PBS / Eagle Detail: Retractable Screen Casement / Awning Application

DAYLIGHT / VIEW AREA CHANGE WITH SCREEN

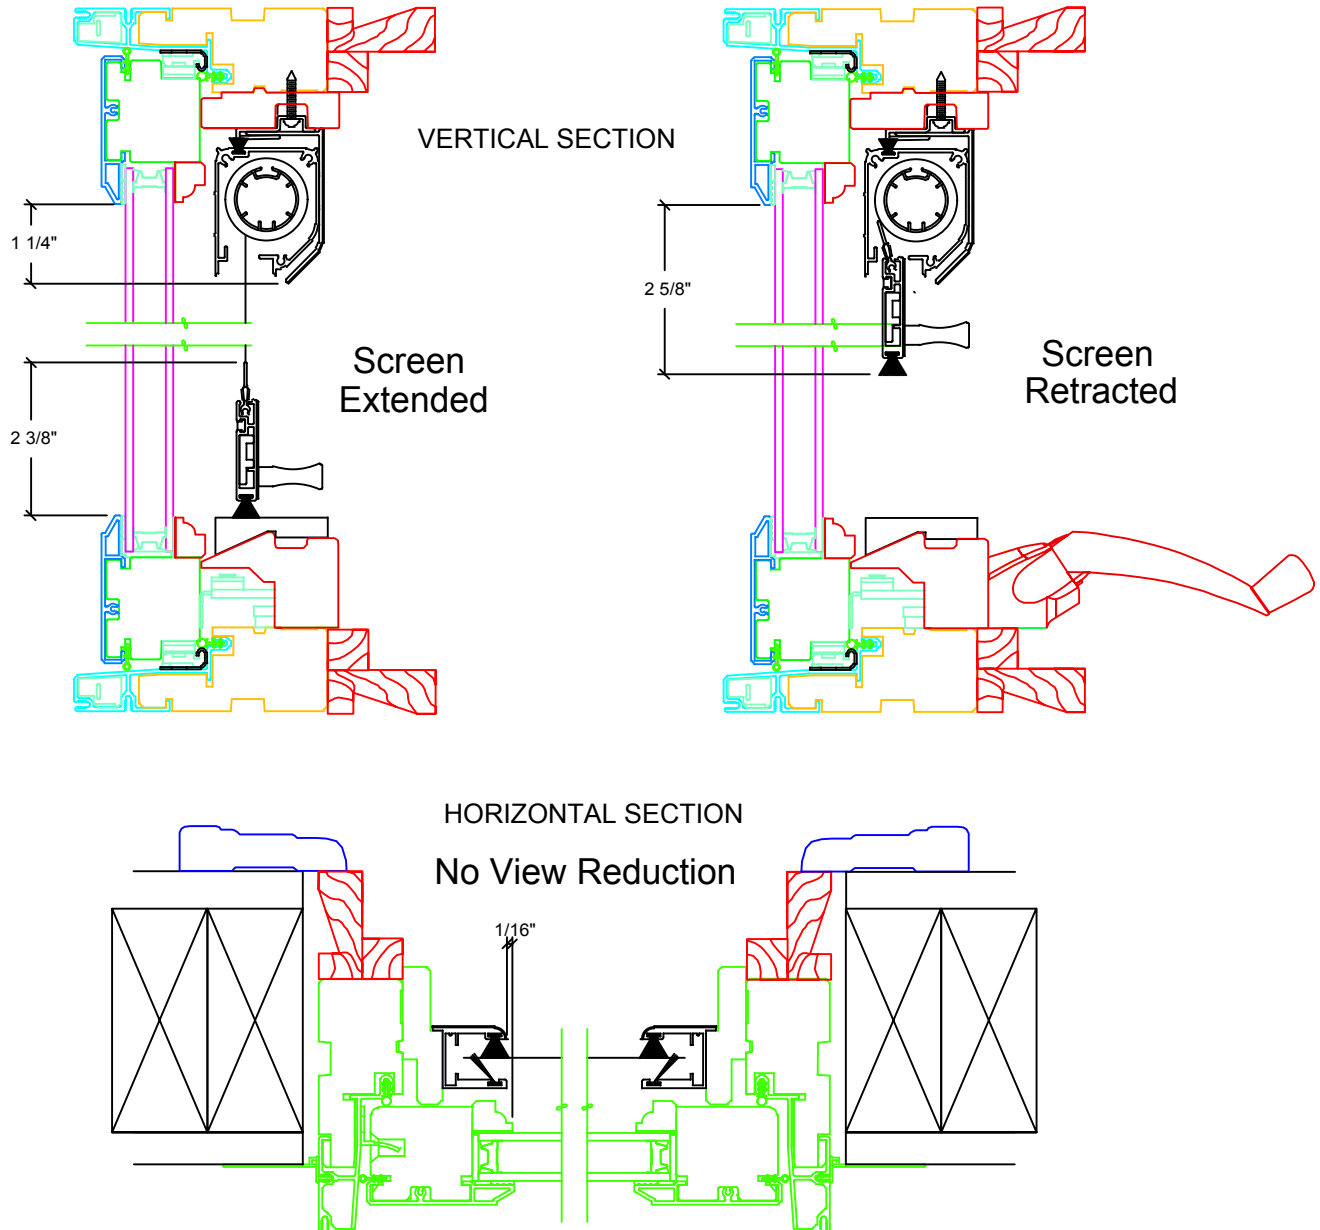
NOTE: Adding a retractable screen will change the clear opening dimensions of a window, and may affect EGRESS requirements in some cases.

With Standard & Egress Hinges the Clear Opening Width is reduced by $1 \frac{1}{32}"$
On units with Piano Hinge, the Clear Opening Width is reduced by $1 \frac{7}{8}"$
Clear Opening Height is reduced by $3 \frac{13}{16}"$ for all hinge types.
Floor to Finished Sill Height increases $\frac{5}{16}"$ for all hinge types.
